Appendix C – Recommended amendments to maps

Mapping Changes

1. The following mapping amendments have been recommended through the Proposed District Plans Hearings Process.

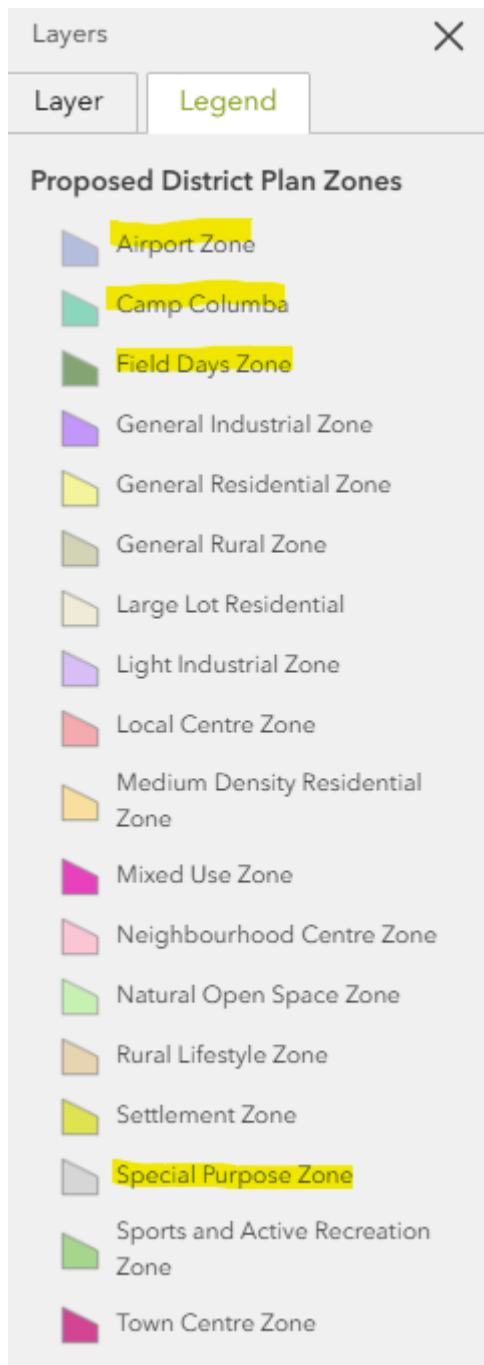
7. Change the map colour for all Special Purpose Zones (Special Purpose Zones include the Airport Zone, Camp Columba Zone, Field Days Zone and Maori Purpose Zones) as per the National Planning Standards colour palette:

8. As shown below the Airport Zone, Camp Columba Zone and Field Days Zone do not have the correct colour. The zones may however be labelled on the maps to differentiate between them.

Special purpose zones		RGB: 204, 204,204
-----------------------	--	-------------------

Figure 4: Proposed amendments to mapping in Mātaura

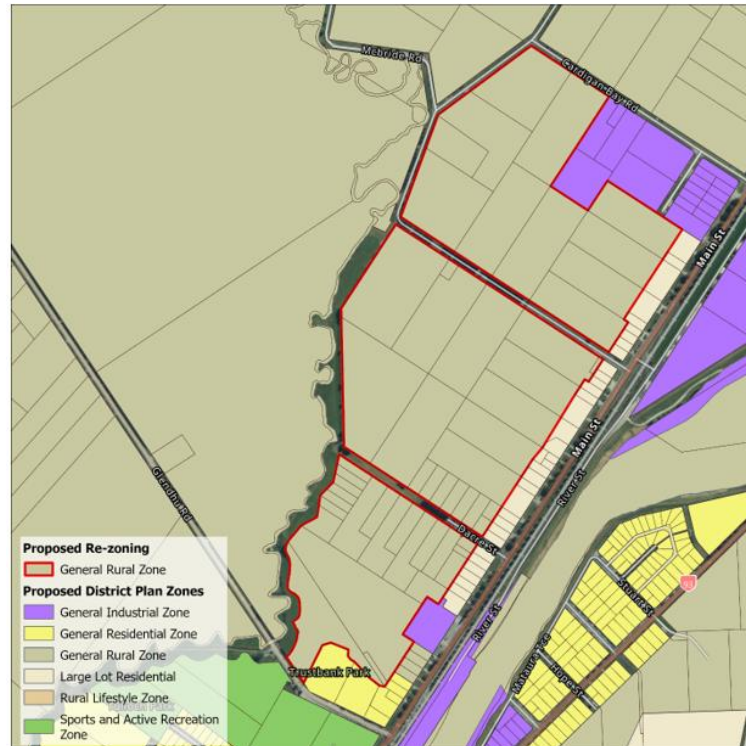
9. The 42A for Rural Zones in Hearing Stream 3 recommends the following mapping changes:
- Mataura: area shown in red outline in Figure 4 below is recommended to be changed from Rural Lifestyle Zone to General Rural Zone.

Figure 5: Proposed amendments to mapping in East Gore

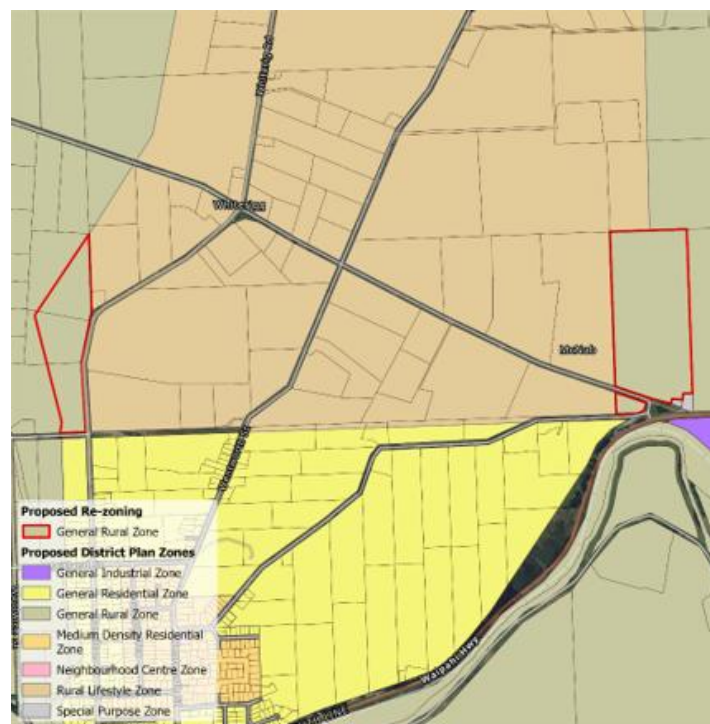
- b) East Gore: area shown in red outline in Figure 5 below is recommended to be changed from Rural Lifestyle Zone to General Rural Zone.

Figure 7: Proposed amendments to mapping in Mandeville Area

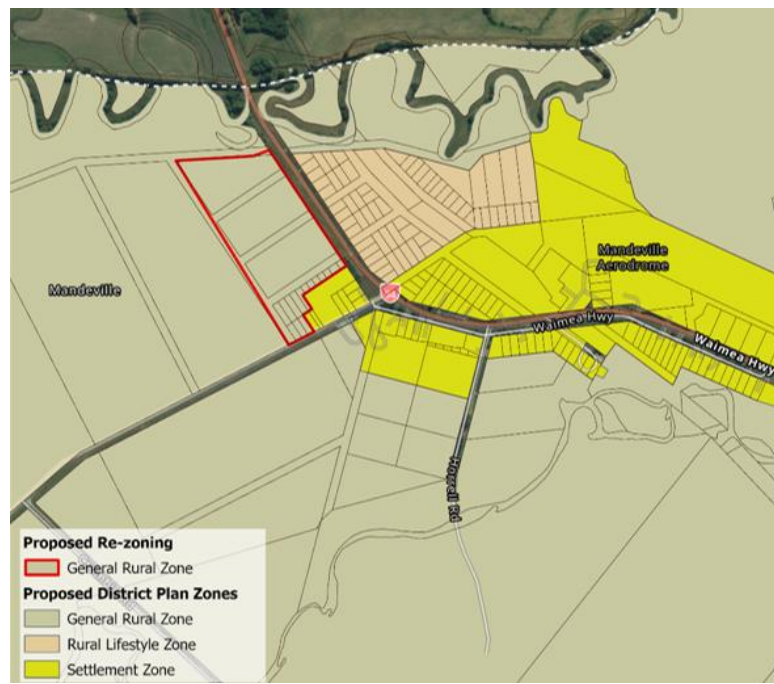
- d) Mandeville area: area shown in red outline in Figure 7 below is recommended to be changed from Rural Lifestyle Zone to General Rural Zone.

Figure 8: Proposed amendments to mapping at 120 Wentworth Street.

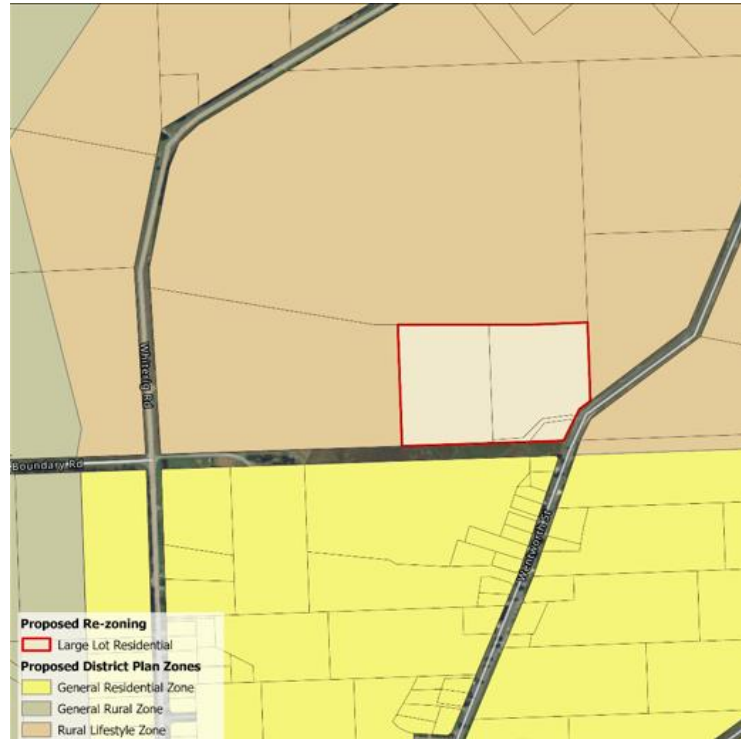
- e) 120 Wentworth Street: area shown in red outline in Figure 8 below is recommended to be changed from Rural Lifestyle Zone to Large Lot Residential Zone.

Figure 10: Proposed amendments to mapping of Reaby Road

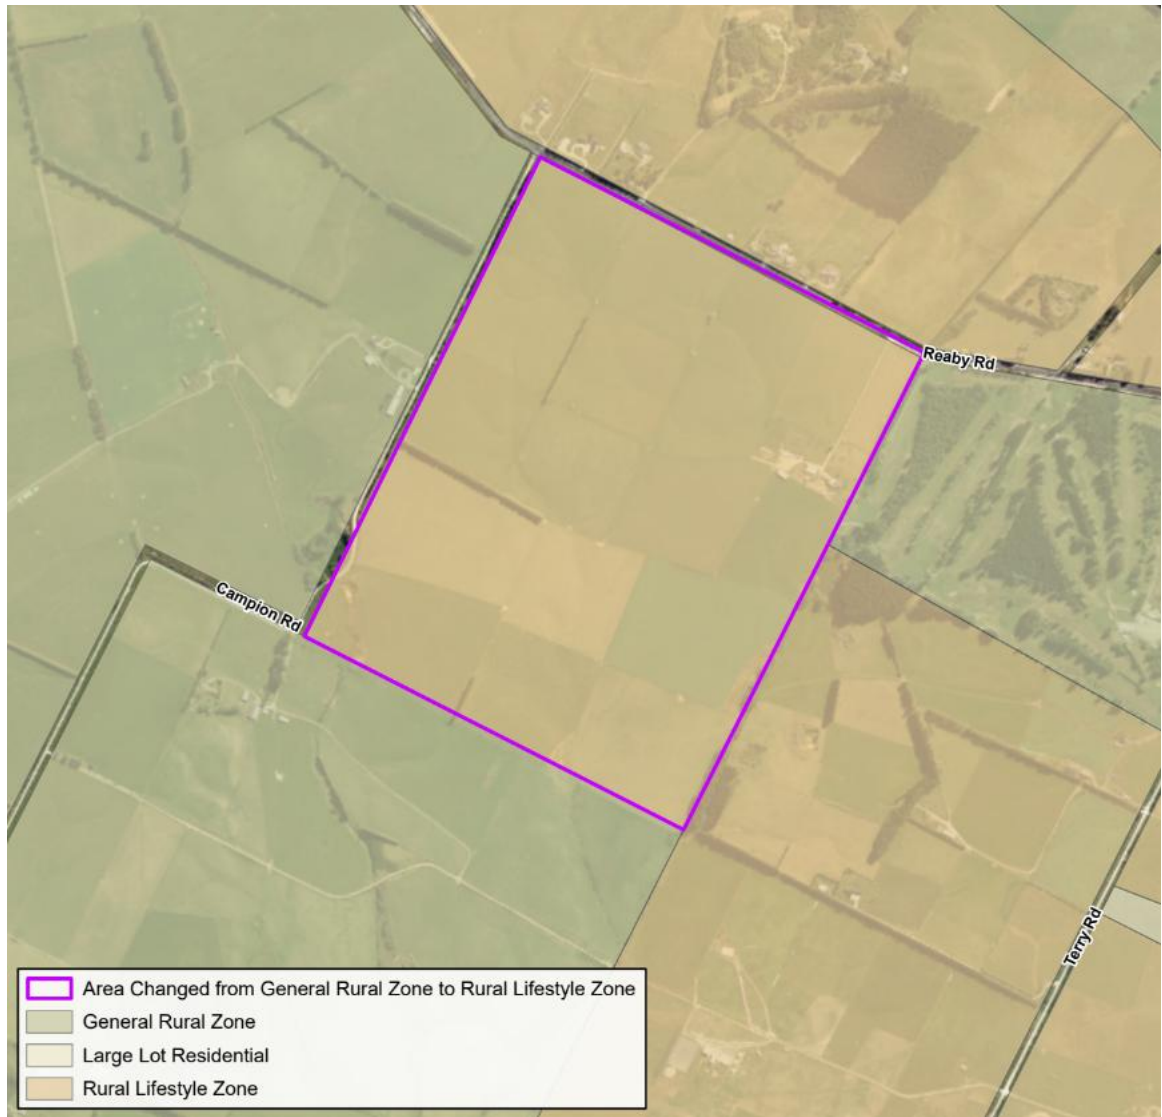
- g) Reaby Road: area shown in red outline in Figure 10 below is recommended to be changed from General Rural to Rural Lifestyle Zone.

Figure 11: Proposed amendments to mapping at Mataura

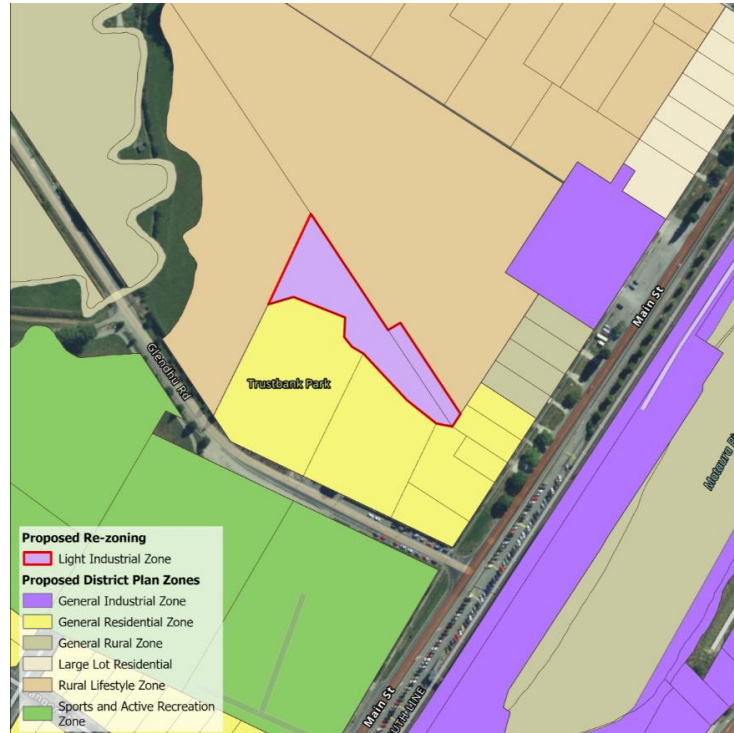
10. The 42A for Industrial Zones in Hearing Stream 4 recommends the following Zone change.
- a) Mataura: area shown in red outline in Figure 11 below is recommended to be changed from Rural Lifestyle Zone to General Industrial Zone.

Figure 13: McNab Rural Industry Precinct Zoning

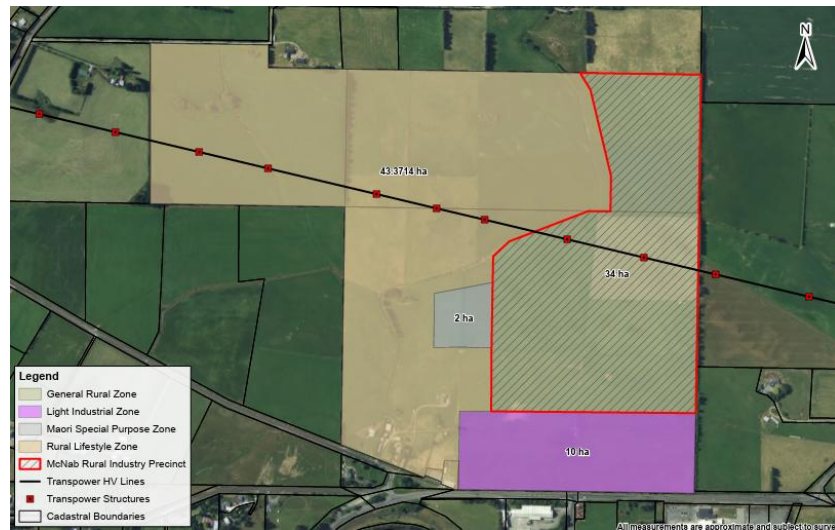
12. If the Panel decides to accept the submission and recommendation for a McNab Development Area, the author of the 42A for McNab rezoning recommends the following mapping changes as shown in Figure 13.

Figure 17: Sensitivity Layers Mapping for the Hokonui Hills

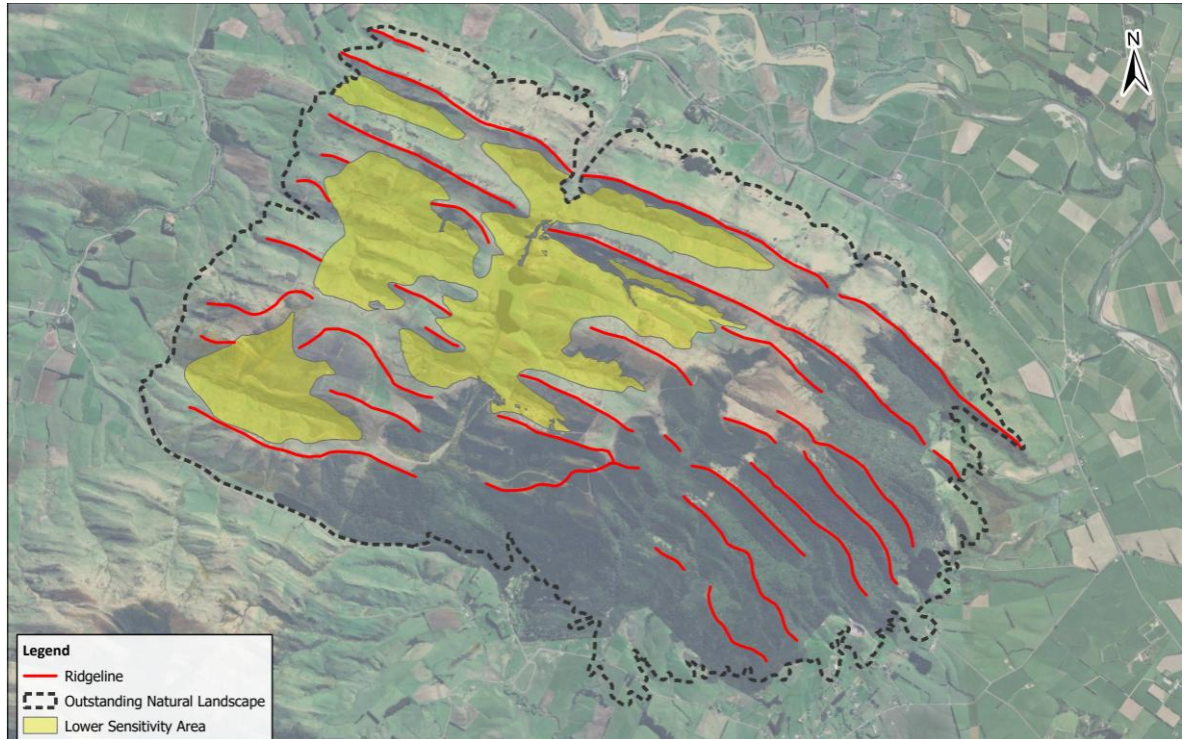
14. The 42A for Rural Zones in Hearing Stream 3 amended the River and Stream order Maps in Appendix 3. It is recommended these maps are included as an information layer.
15. The 42A for Natural Features and Landscapes in Hearing Stream 10 recommends mapped sensitivity layers (ridgeline vs lower sensitivity areas) in the Hokonui Hills ONF as shown in Figure 17 below.

Figure 18: Hokonui Hills Vegetation Mapping

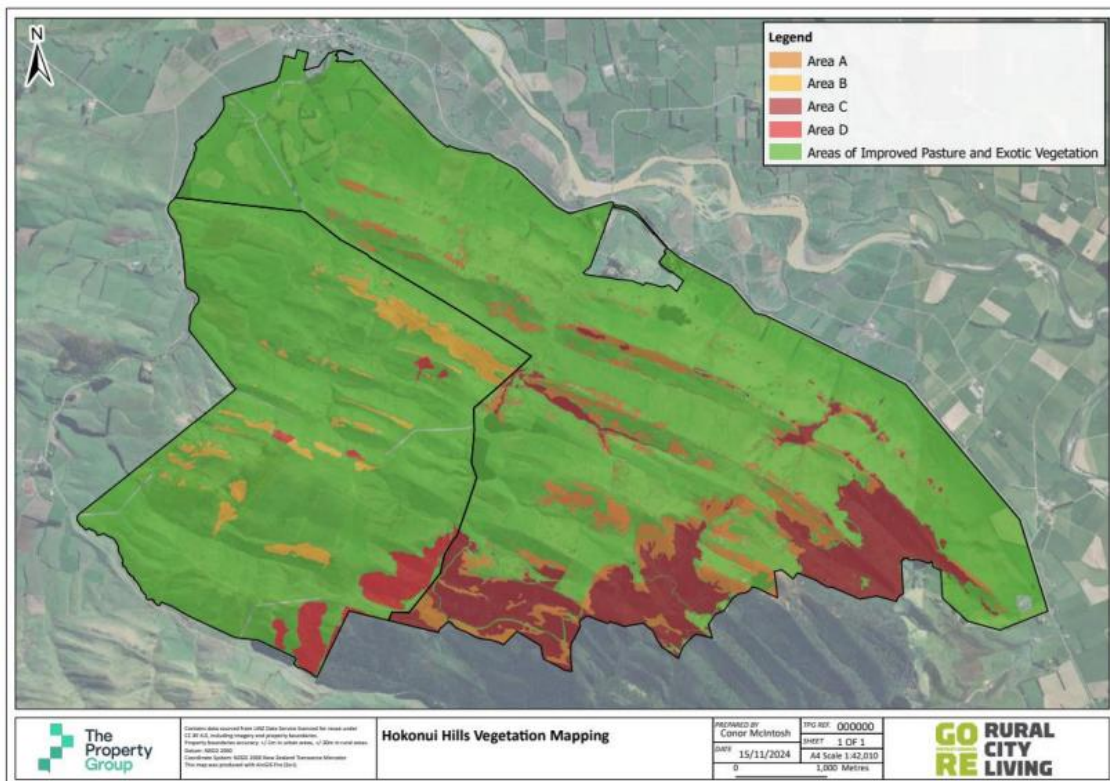
16. The 42A for Ecosystems and Indigenous Biodiversity in Hearing Stream 11 (HS11) recommends including Hokonui Hills Vegetation Mapping as Appendix 7 to the PDP as shown below in Figure 18. Indicative mapping, to sit outside the PDP as an information layer, of Significant Indigenous Vegetation Areas (SIVA) and Indigenous Vegetation Areas (IVA) were also recommended in HS11 (refer Figure 19 below). These maps may be amended in response to Minute 41 which will be considered in the reconvened ECO hearing on 8 April 2025.
